**PUR-1344**  
**ADDENDUM NO. 3**  
**INVITATION TO BID**

**HANCOCK LIBRARY**

**DATE: Wednesday, May 31, 2017**

**ELECTRICAL SITE LIGHTING PLAN**  
 SCALE: 1"=20'-0"

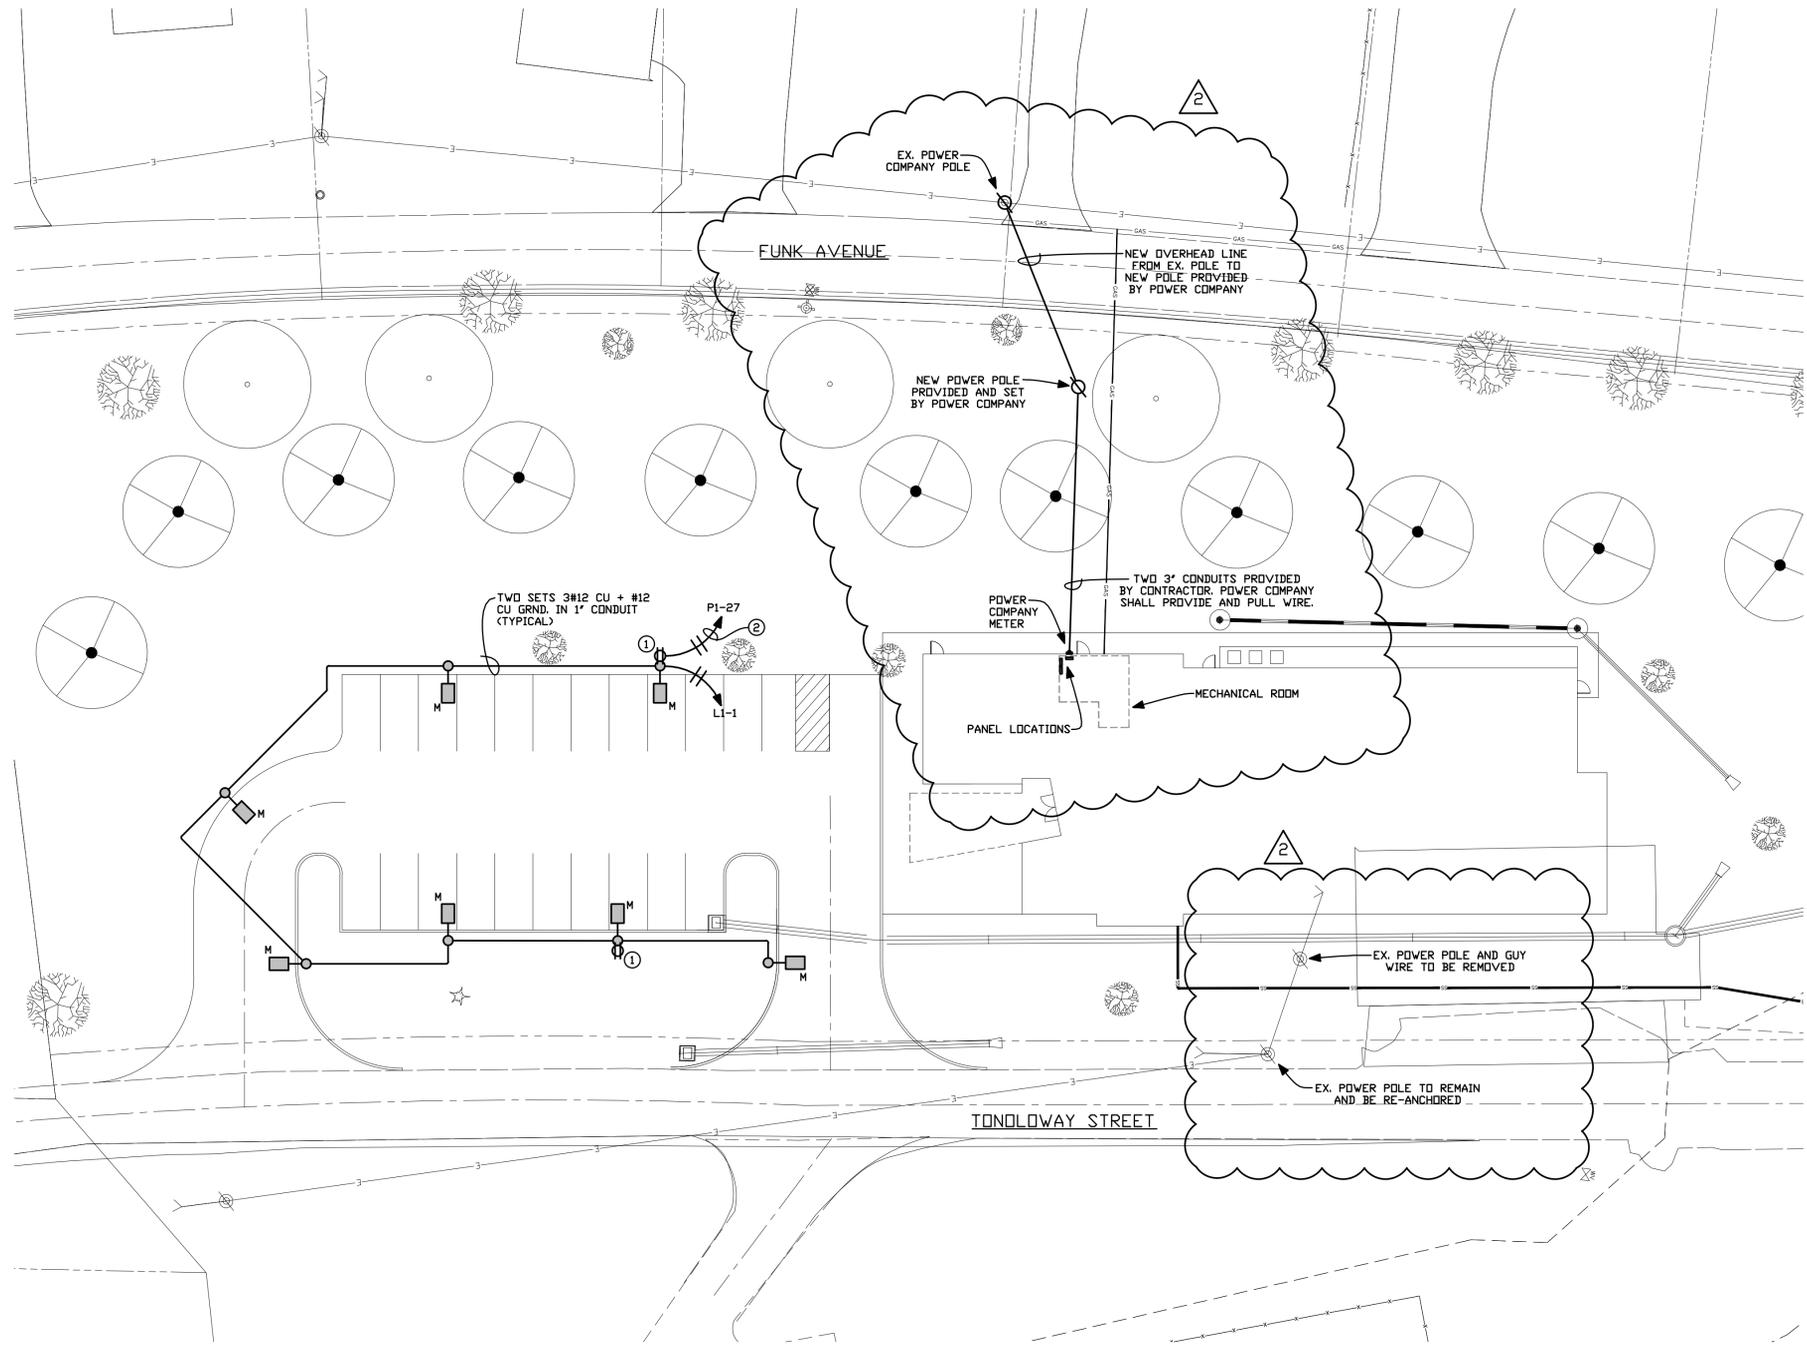
**ITEM NO. 16: Drawing E-3.1: Electrical Site Lighting Plan:**

Drawing E-3.1 (attached) has been revised at the request of the Power Company to re-route the main power from Funk Avenue to the back of the building, instead of placing a power meter on the front of the building and bringing power from an existing pole just off of Tonoloway Street. Notes have been added to the Drawing to detail those Changes. Contractor will dig trench and provide conduit from new power company pole to power meter at the back of the building. The Power Company will set the new pole, run wire overhead, and then underground through Contractor's Conduit and make connection to power meter.

**ELECTRICAL POWER RISER**  
 NOT TO SCALE

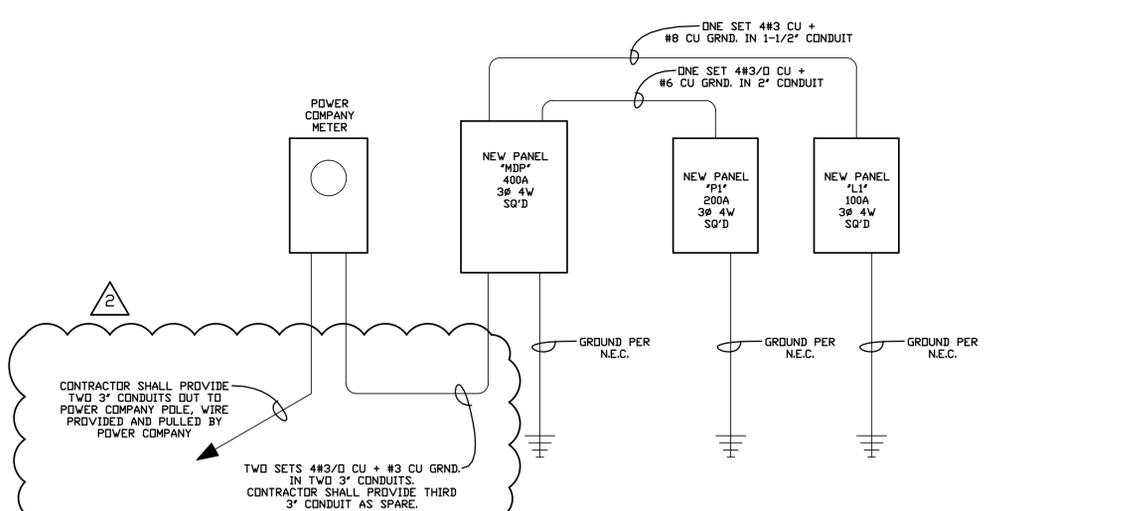
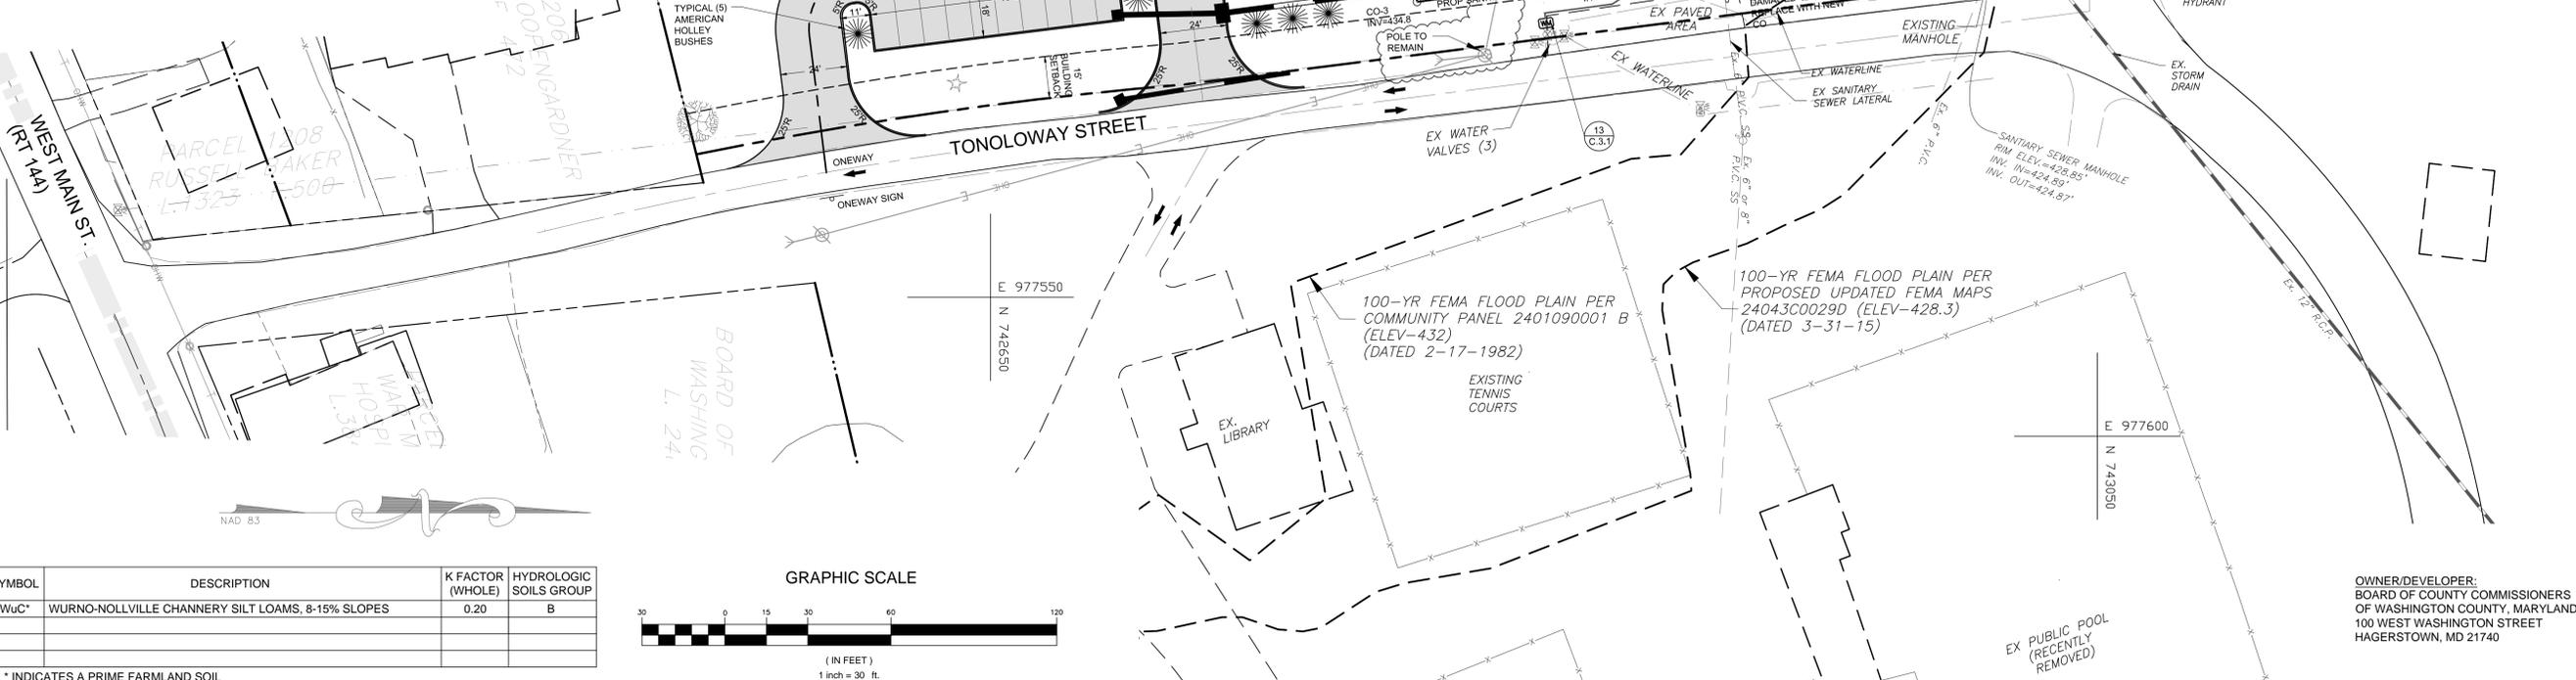
**ITEM NO. 17: Drawing E-5.0: Electrical Power Riser and Schedules:**

Drawing E-5.0 (attached) has been revised to add/edit notes on the Electrical Power Riser to accommodate for the changes being made by re-routing the main power.
